# ADDENDUM NO. 2

**October 24, 2023**

**Bid Package No. 2 - LOWELL HIGH SCHOOL RENOVATIONS AND NEW SPORTS COMPLEX**
**Lowell, IN 46356**

DRAWING
NORTH STAR BUILDING FIRST FLOOR PLAN

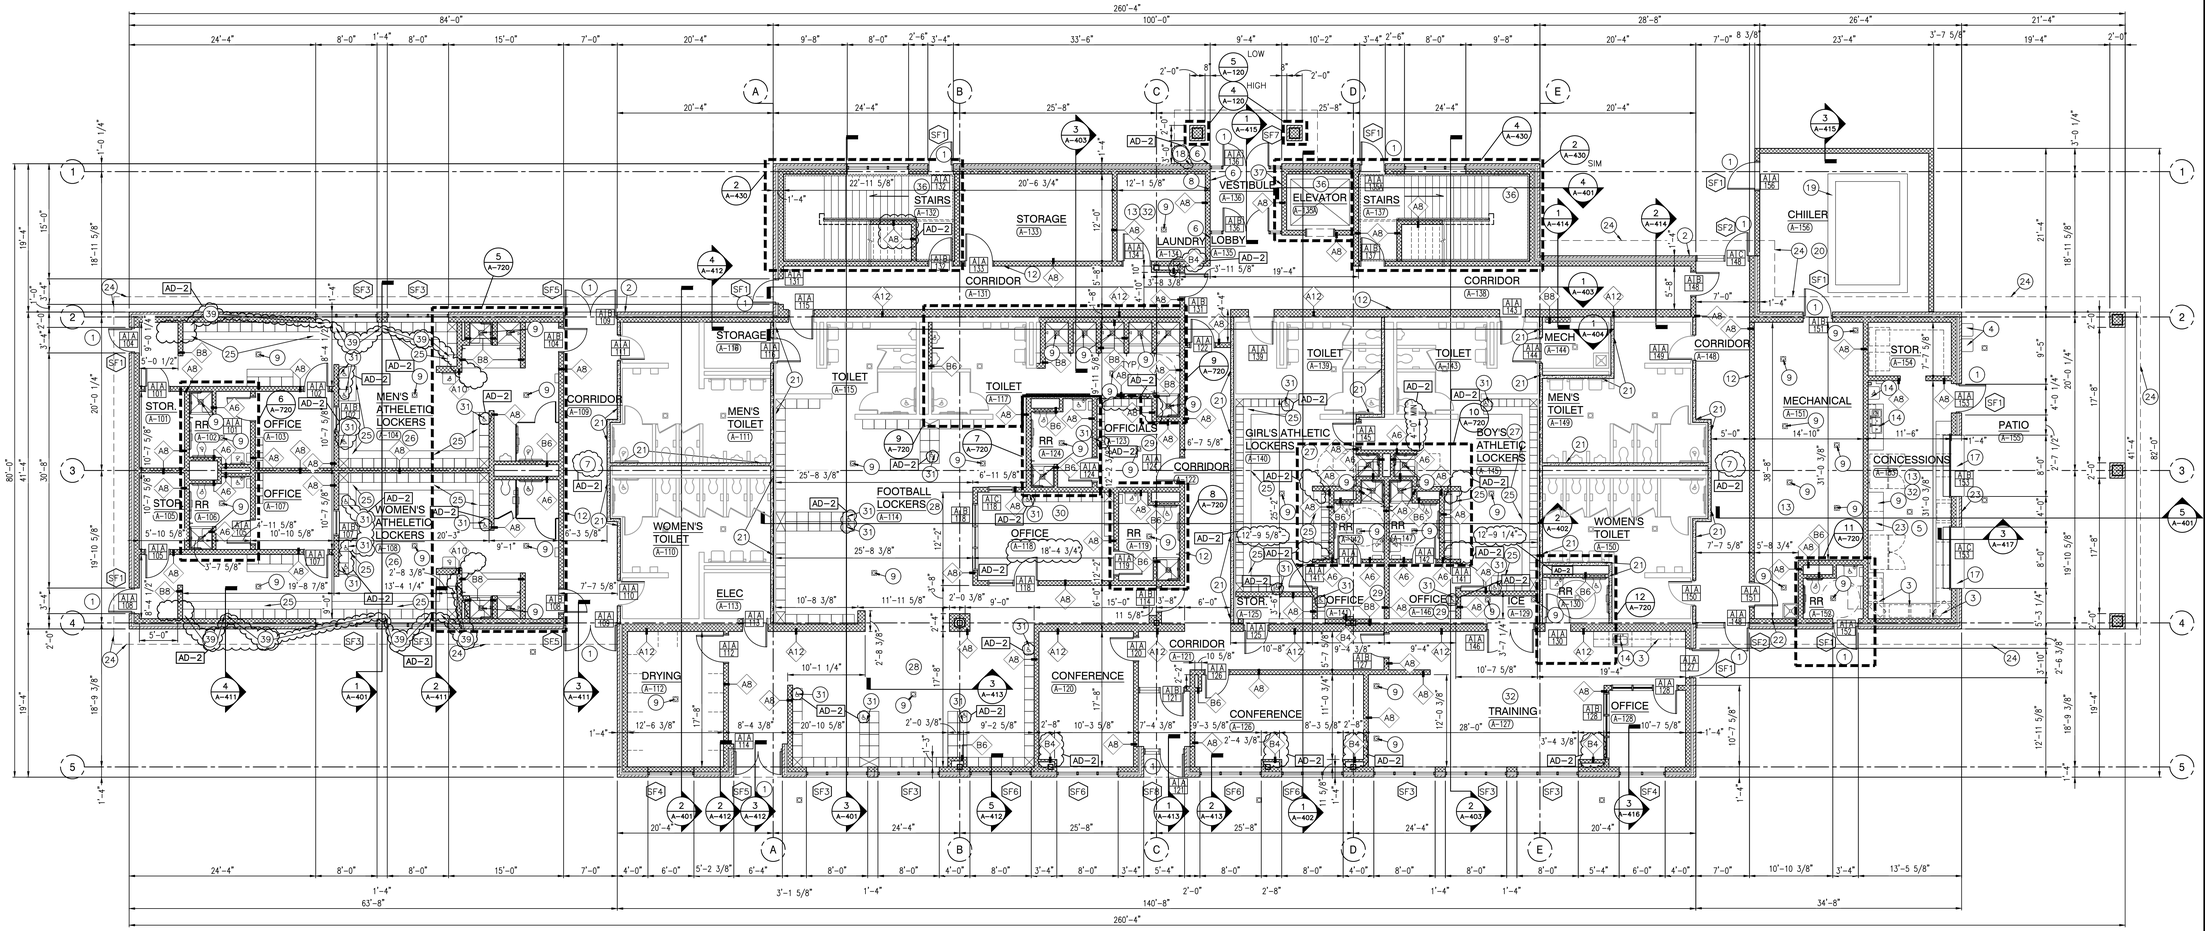
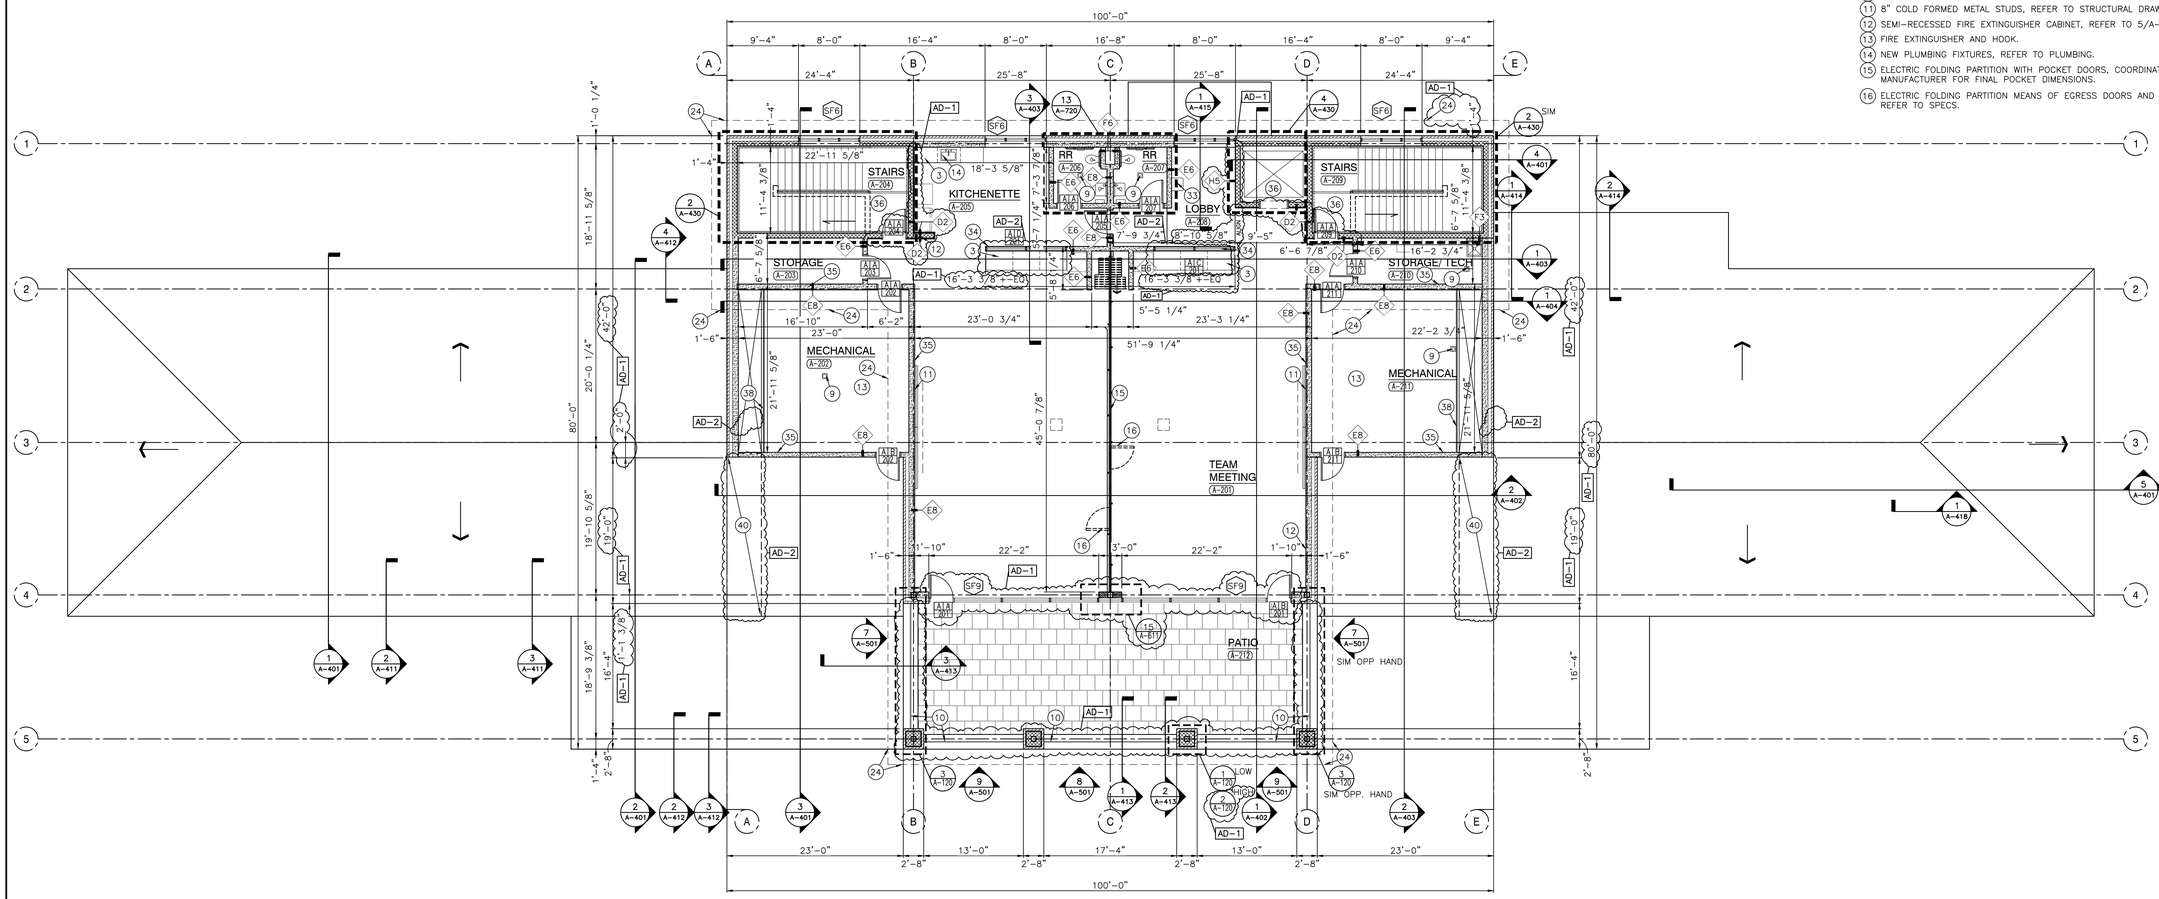
1. Additional wall type markers added as indicated.
2. Office A-118; Dimension modified for clarity.
3. A-123 Officials'; Revise chase and add additional locker.
4. Revise dimensions as indicated.
5. Clarify locker interface with window above and sloped top.
6. Clarify location of Knox Box.
7. Clarify location of interstitial space access at bottom of trusses.
8. Clarify wall closure to construction above ceiling.

## NORTH ELEVATION

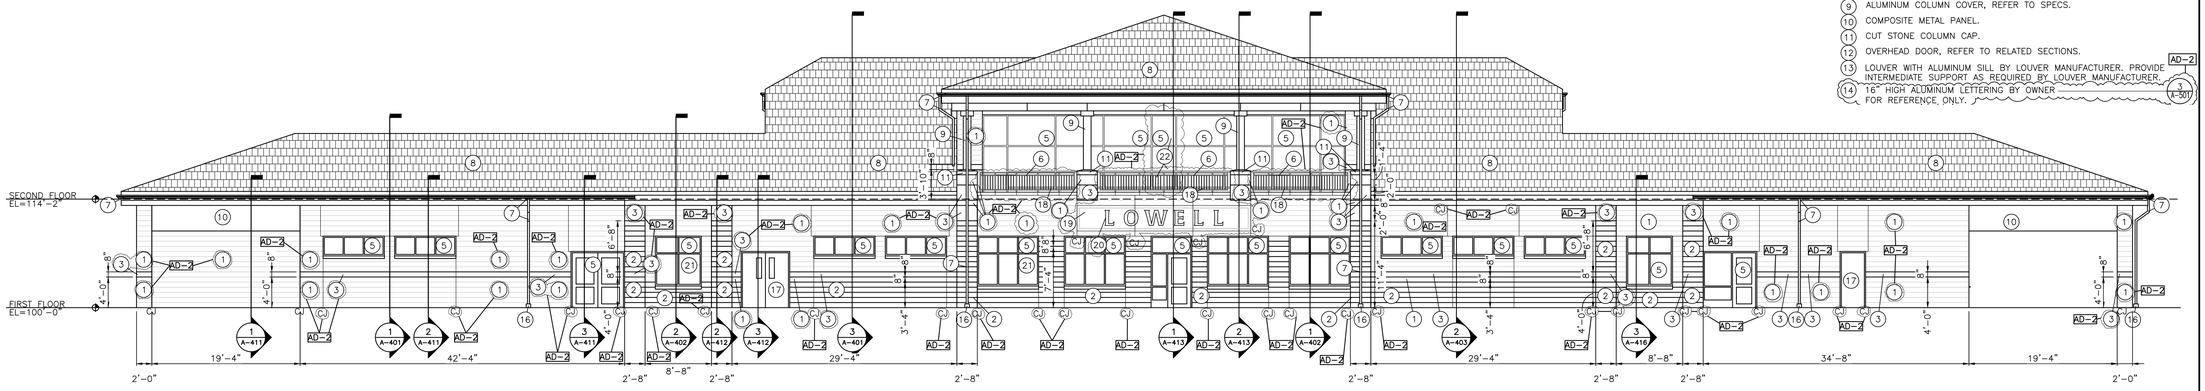
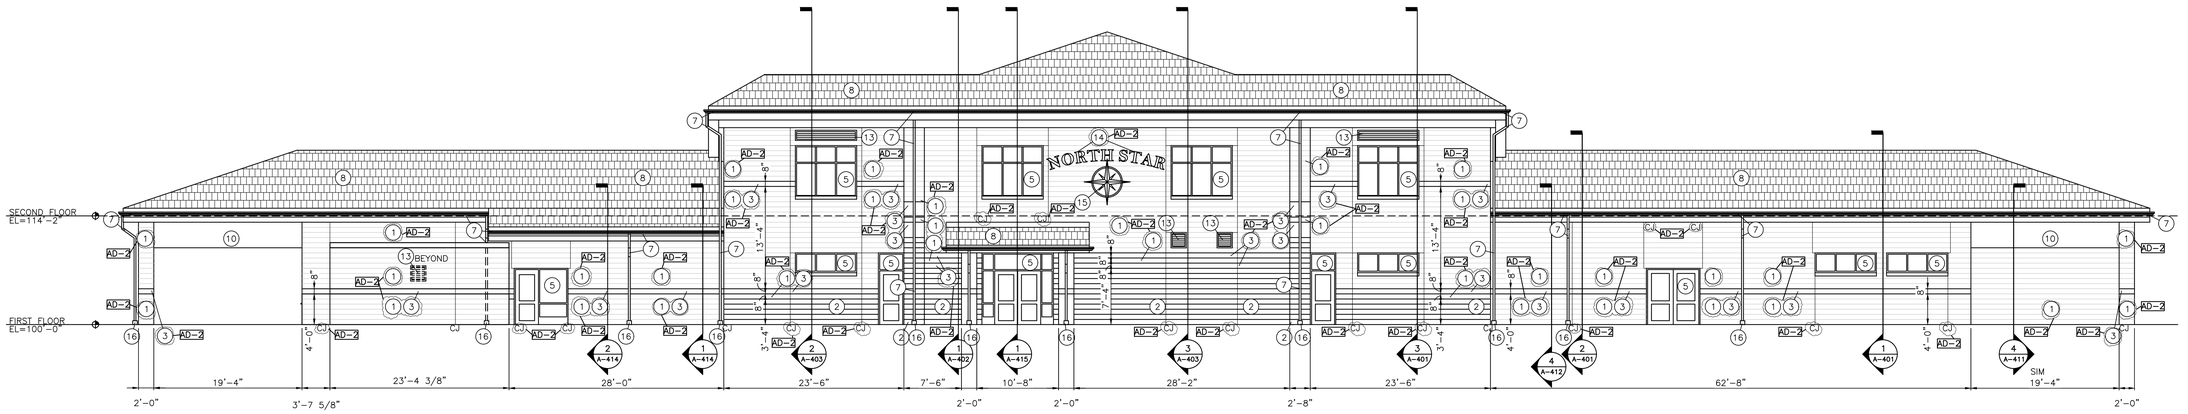
1. Revise storefront and surrounding area on South Elevation.
2. Revise railing and surrounding masonry on South, East and West Elevations.
3. Revise masonry types as indicated.
4. Revise masonry control joints as indicated.
5. Revise cut stone with engraved school name as indicated.
6. Revise notes and section cuts as indicated.
7. Revise Elevation Notes as indicated.

DRAWING
SITE BUILDINGS - WALL SECTIONS

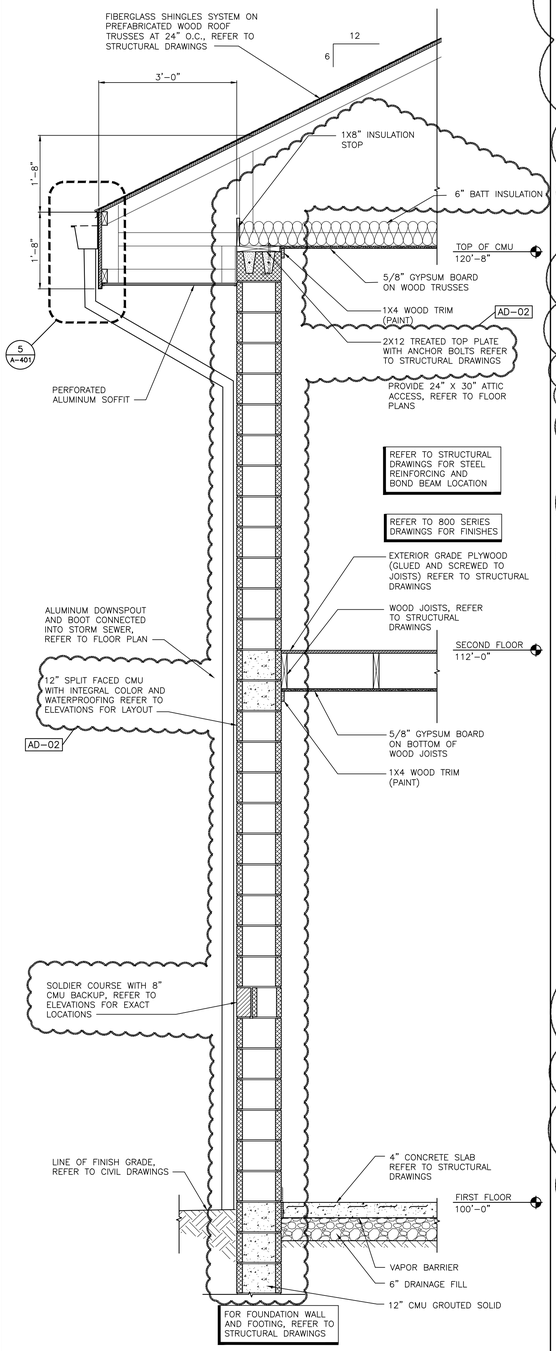
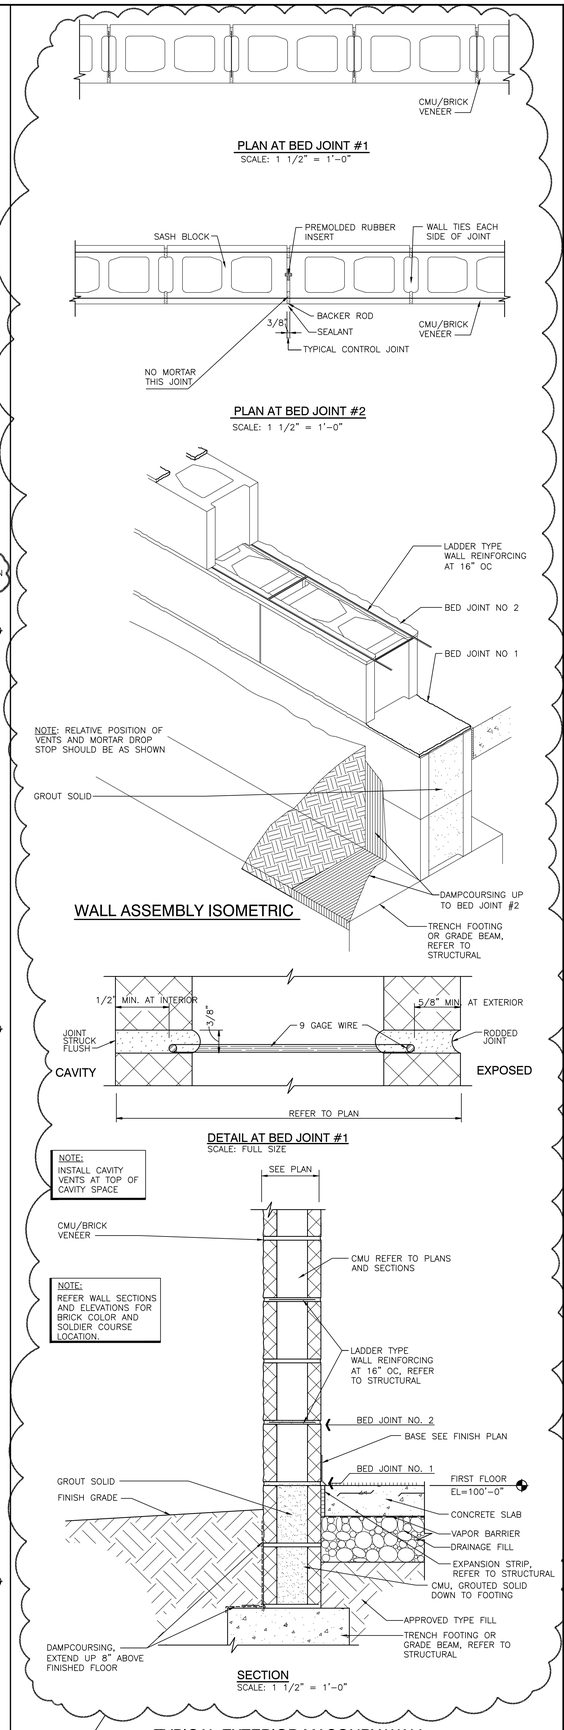
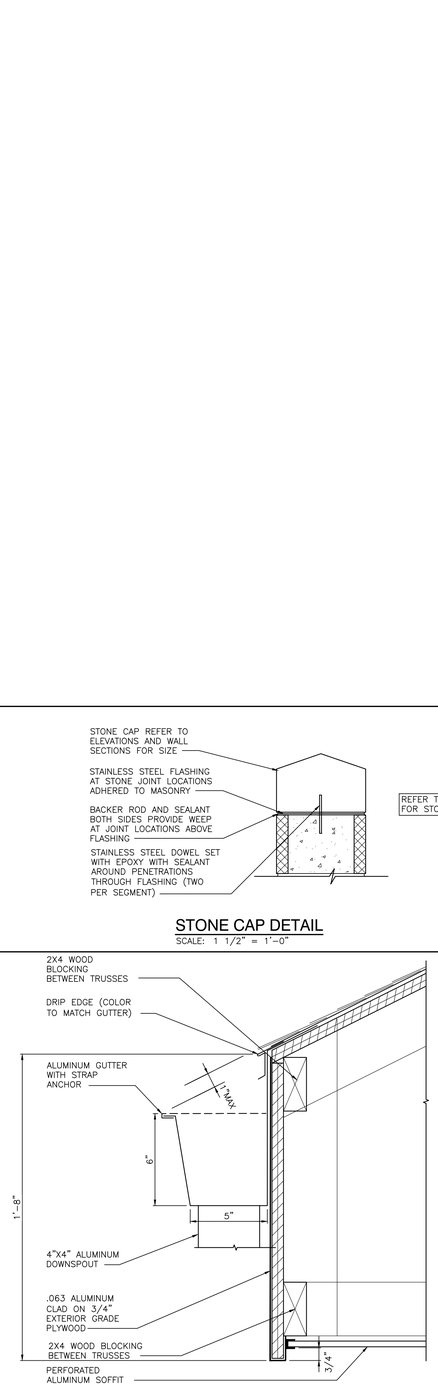
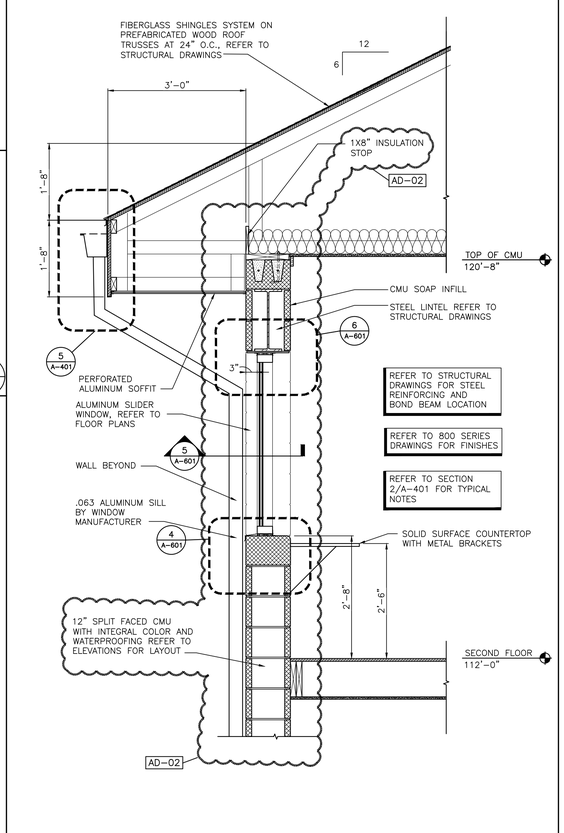
A. Refer to revised full-size drawing included in this Addendum for the following revisions:
   1. Revise sections 2-4 to show 12" CMU in lieu of 4" CMU, Insulation, and 8" CMU.
   2. Revise sections 2-4 to only have split faced CMU in lieu of Split, smooth, and fluted.
   3. Revise sections 2-4 to reduce attic insulation thickness.
   4. Revise section 2 to show brick solder course and CMU backing.
   5. Revise detail 1 to show revision to CMU.
